**STATE OF MINNESOTA
BEFORE THE PUBLIC UTILITIES COMMISSION**

In the Matter of Xcel Energy's 2016-2030
Upper Midwest Resource Plan

PUC Docket No. E002/RP-15-21

CLEAN ENERGY ORGANIZATIONS' INITIAL COMMENTS

Figure 8. Figure from Xcel’s July 2013 LCM study comparing system emissions of “retirement” (in 2020/2023) to installation of SCRs (retirement in 2040).

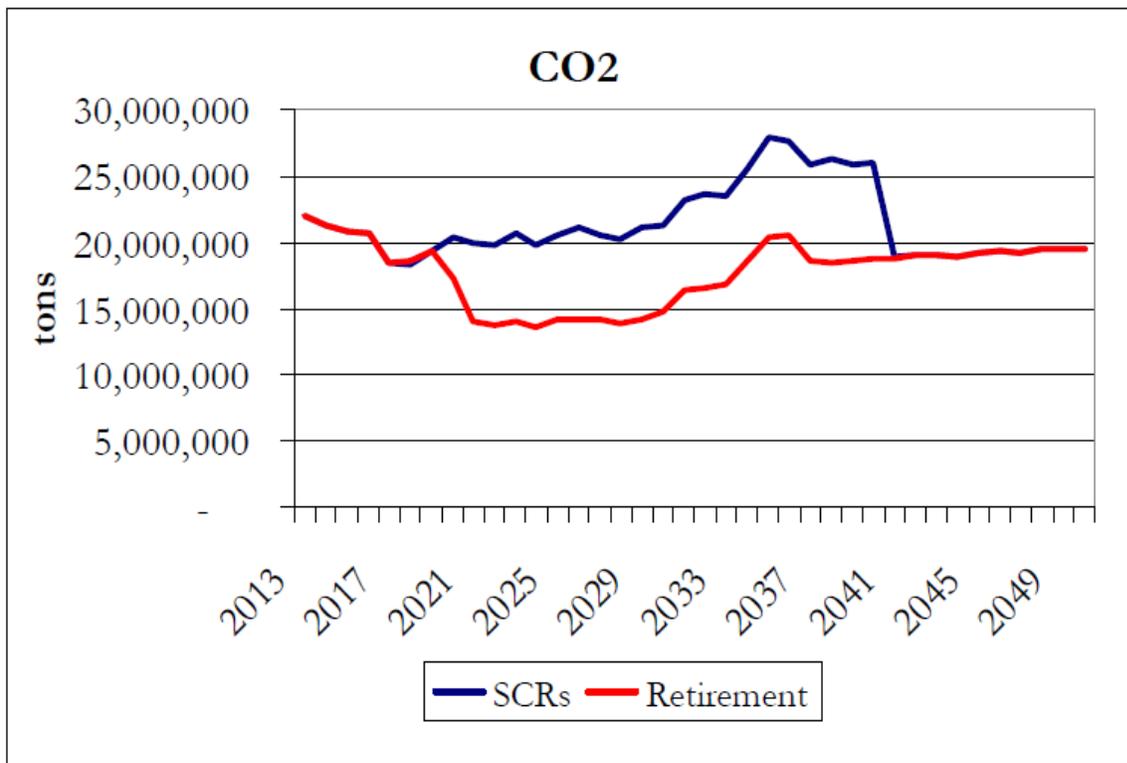
Indeed, as Figure 8 demonstrates, in the Sherco Life-Cycle Management study Xcel concluded that system CO₂ emissions would remain over 20 million tons for many years absent the retirement of Sherco 1 and 2.

The emissions profile from the Lifecycle Management Study stands in stark contrast to the March 16, 2015 supplement. The difference in 2030 between the 2013 LCM study and the current IRP is approximately 3.625 million tons of CO₂.

Figure 10. Xcel MISO Sales and Purchases, 2011-14

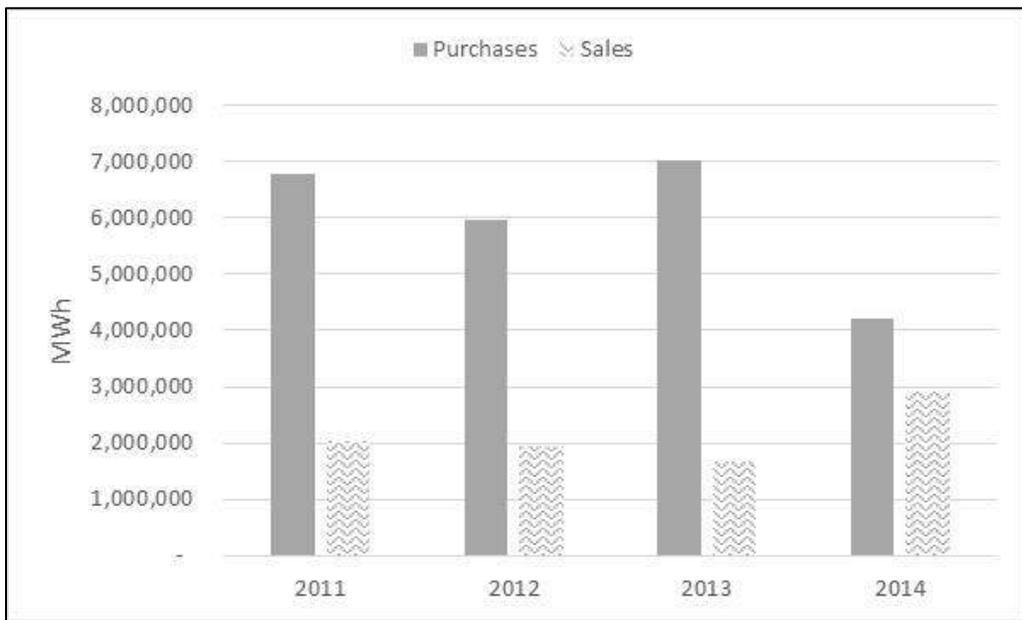
The modeling convention of ignoring MISO purchases further biases Xcel’s modeling results related to GHG emissions. As Figure 10 below demonstrates, MISO sales and purchases have historically had a non-trivial role to play in Xcel’s system mix.

Xcel has historically purchased large quantities of electricity from MISO – and has, in the last four years, been a net purchaser of electricity from MISO. This dynamic matters because as discussed above, Xcel has a lower average rate of CO₂ emissions than does MISO. As a result, as the balance of purchases and sales changes from year to year, Xcel’s ability to meet the GHG goal will also likely change.

Figure 11. Realistic System Emissions, Including Adjustments to Xcel’s Coal Fleet Emissions, the Dump Energy Emissions Rate, and Wholesale Purchases and Sales Mean that Xcel Could Fail to Meet the Next Energy Generation Act GHG Glide Slope²⁸

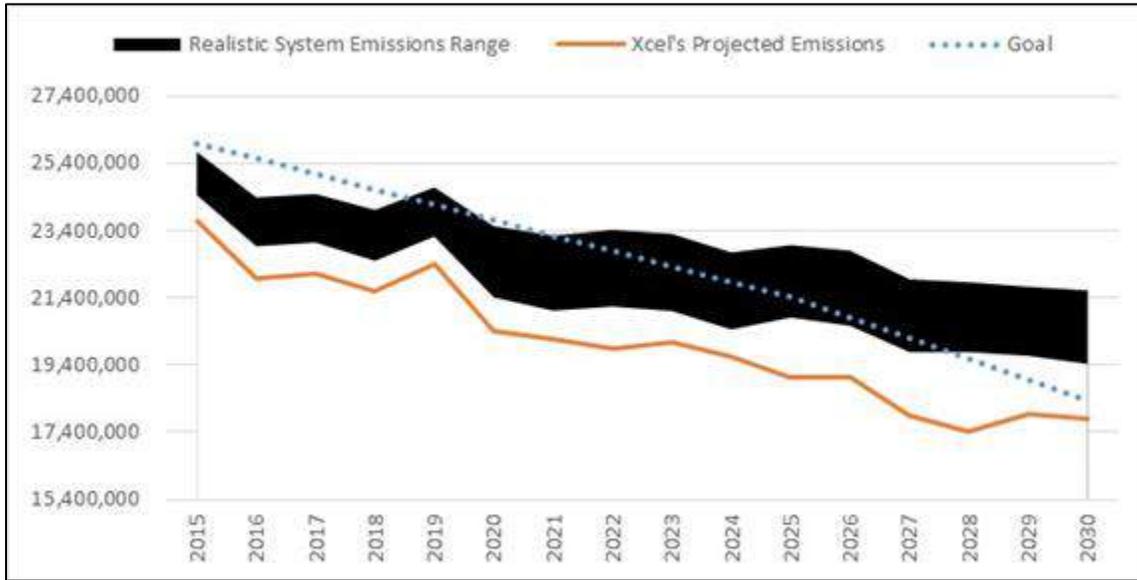
Figure 11 shows that the realistic range of projected emissions under Xcel's Preferred Plan is significantly higher than Xcel calculated and, moreover, that the Plan does not satisfy the state's GHG reduction goals. The high end of the "Realistic" range assumes purchases equal to the greatest number of megawatt-hours purchased from MISO by Xcel in the past four years, but balanced out with sales so that energy need is exactly met. The lower range assumes only the corrected emissions accounting for sold dump energy as well as emissions from likely coal generation. Figure 11 demonstrates that those factors over which Xcel has little control, i.e., how much generation its coal fleet produces and how much energy is purchased from and sold into MISO, can materially impact the Company's ability to comply with the GHG goal.

Figure 15. Current Potential Study Savings Estimates are Much Higher than in the Sherco LCM Study

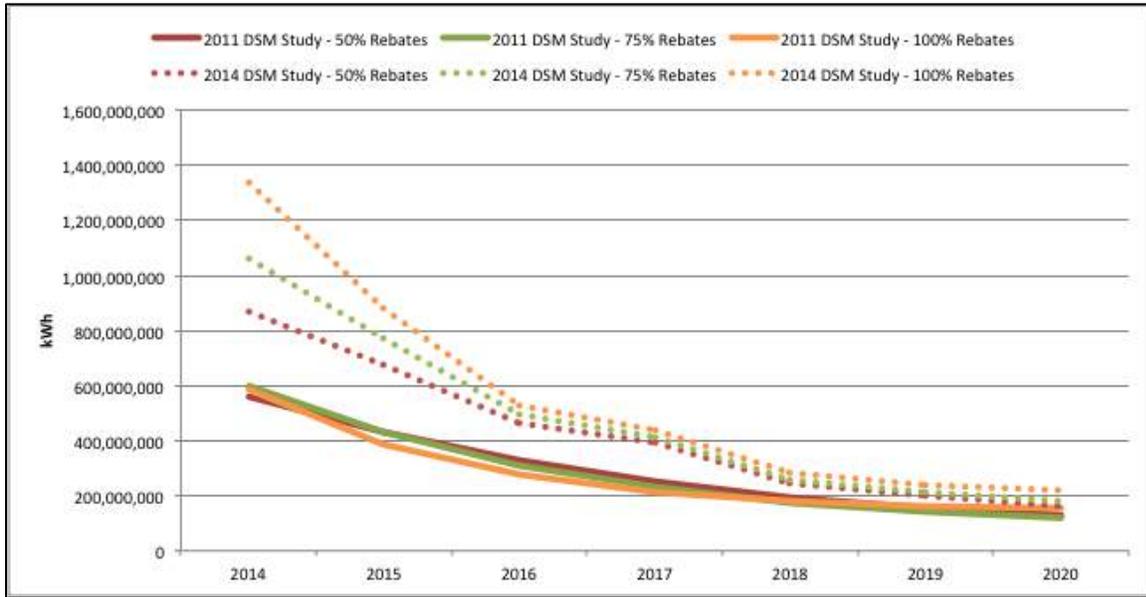
During its 2013 Life-Cycle Management Study, Xcel used the results of the 2011 version of KEMA's study to estimate energy efficiency impacts. Since that time, the study has become more optimistic about the potential for savings on Xcel's system.

As Figure 15 shows, the current study includes significantly more savings – a total of 961 to 1,967 GWh worth of additional savings depending on the scenario.

Figure 20. The Clean Energy Plan’s Efficiency Costs are Conservatively High, While Xcel’s Cost Assumptions are Unrealistically High

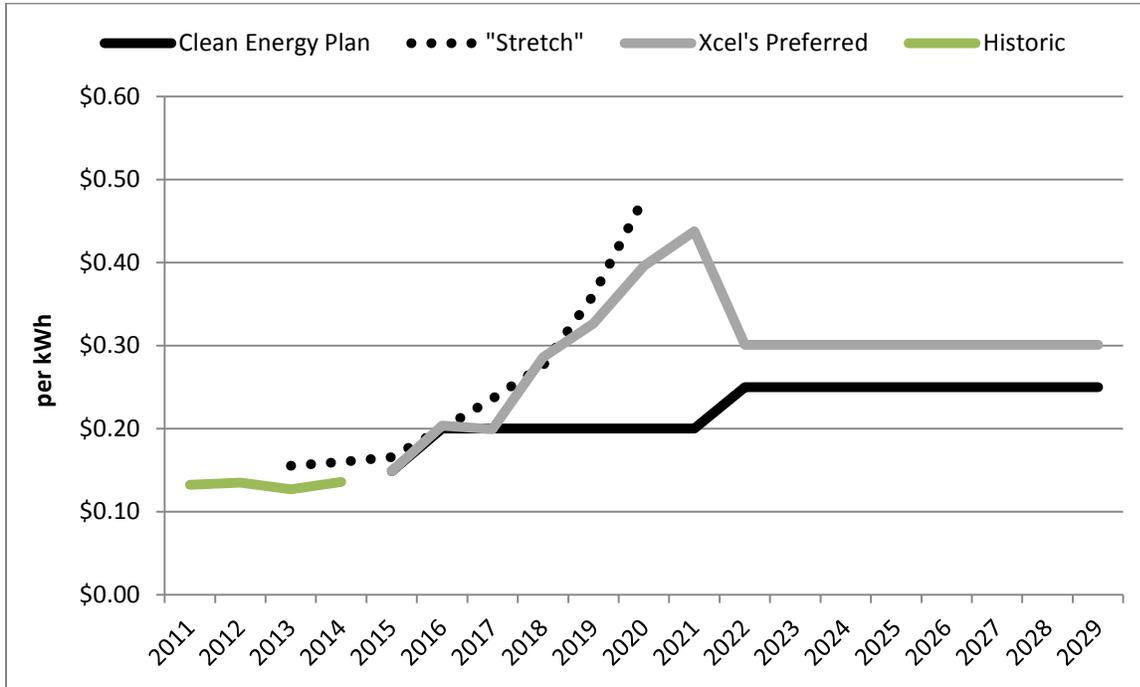
As Figure 20 shows, despite the initial ratcheting down of EISA lighting standards between 2012 and 2014, Xcel’s cost of efficiency has remained relatively unchanged. Xcel’s Preferred Plan costs rise dramatically in part because Xcel assumes that it would have to pay a much higher percentage of incremental cost (jumping from 30% to 50+% on average) in order to get *fewer* savings that it has achieved in the past. The Clean Energy Plan assumptions, which jump from historic cost levels of \$.13 to \$.14 per kWh to \$.20 per kWh from 2016 to 2021 (*a 43% increase*) and then \$.25 per kWh from 2022 to 2029 (*a further 25% increase*) should be viewed as conservatively high assumptions rather than the unrealistically and unreasonably high numbers Xcel uses.

The cost trajectory in Figure 20 shows just the first year costs for the first column in this table. In other words, Xcel’s Preferred Plan assumes 1.5% savings through 2021 and then 1.3% through 2029. Xcel’s assumptions about cost for the other EE scenarios are very different and much higher.

Figure 24. Xcel’s EE Cost Assumptions are Unreasonably High not Just in its Preferred Plan (1.5% w/ 1.3% Tail) but also in its Alternative EE Scenarios

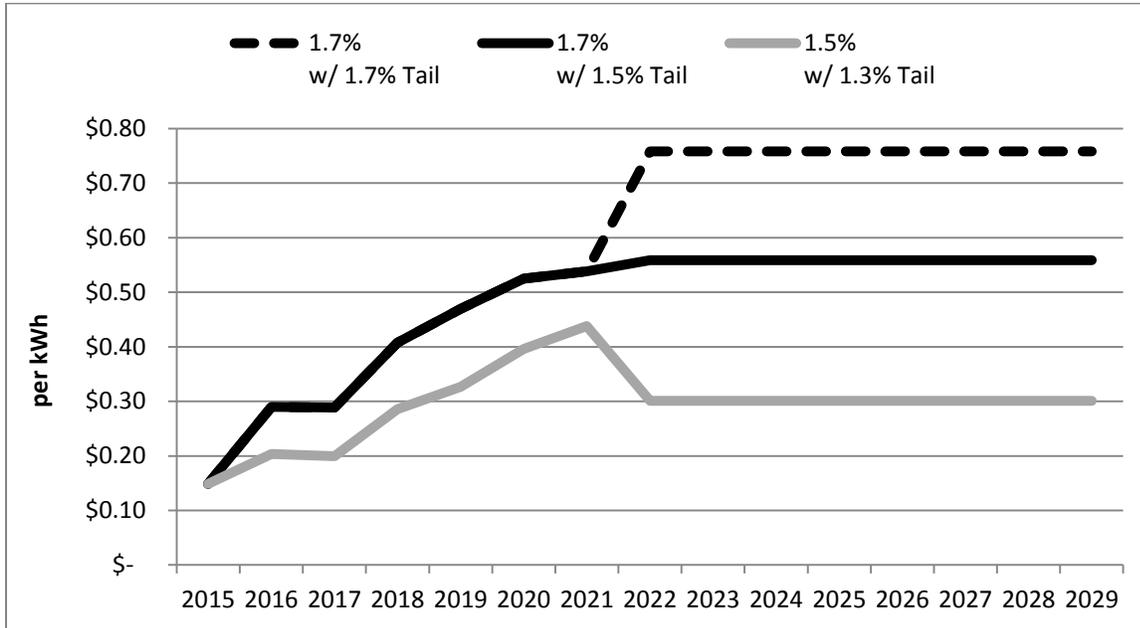
When CEO’s conservatively high EE costs are substituted for Xcel’s, then it becomes clear that higher levels of EE are indeed cost-effective.
